Project	<b>IEEE 802.16 Broadband Wireless Access Working Group</b> < <a href="http://ieee802.org/16">http://ieee802.org/16</a> >	
Title	<b>Comments on CDMA-based HO Ranging Procedure for IEEE P802.16m/D2 (15.2.6.3.5.1)</b>	
Date Submitted	<b>2009-11-06</b>	
Source(s)	Yih-Guang Jan, Yang-Han Lee, Hsien-Wei Tseng, Ming-Hsueh Chuang, Jheng-Yao Lin <b>Tamkang University (TKU)</b>	yihjan@yahoo.com
	Youn-Tai Lee, Chun-Yen Hsu <b>Institute for Information Industry (III)</b>	lyt@nmi.iii.org.tw
	Shiann-Tsong Sheu <b>National Central University (NCU)</b>	stsheu@ce.ncu.edu.tw
	Whai-En Chen <b>National Ilan University (NIU)</b>	wechen@niu.edu.tw
Re:	IEEE 802.16 Working Group LB30a: P802.16m/D2	
Abstract	Comments on CDMA-based HO Ranging Procedure s for IEEE P802.16m/D2 (15.2.6.3.5.1)	
Purpose	To be discussed and adopted by TGM for IEEE P802.16m/D2.	
Notice	<i>This document does not represent the agreed views of the IEEE 802.16 Working Group or any of its subgroups. It represents only the views of the participants listed in the "Source(s)" field above. It is offered as a basis for discussion. It is not binding on the contributor(s), who reserve(s) the right to add, amend or withdraw material co

Figure 406 MS State machine during HO network re-entry

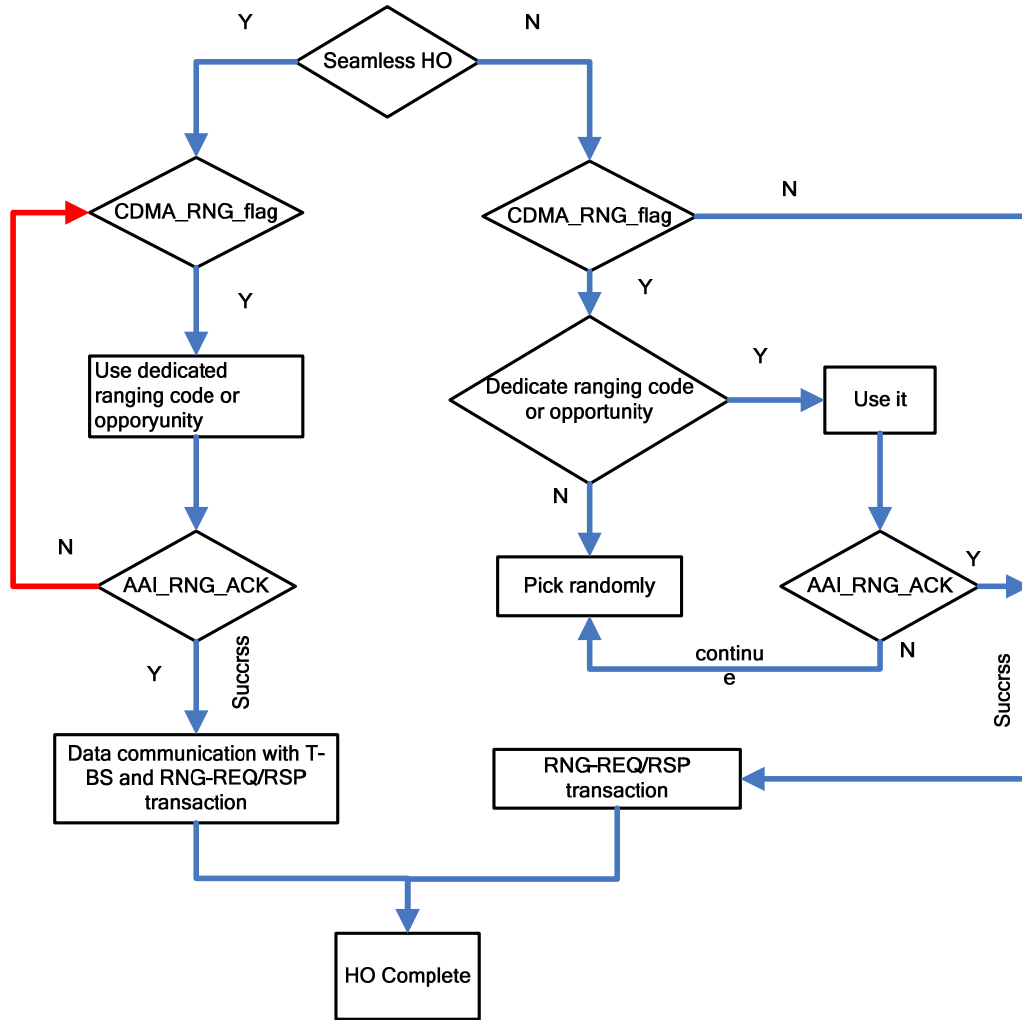
This contribution provides the corrected figure in the description of CDMA-based Ranging Procedure. It has some errors in Figure 406 in the description of ‘MS based state machine during HO network re-entry’.

*[In IEEE P80216m/D2, Section 15.2.6.3.5.1, replace Figure 406 by the following corrected figure]*
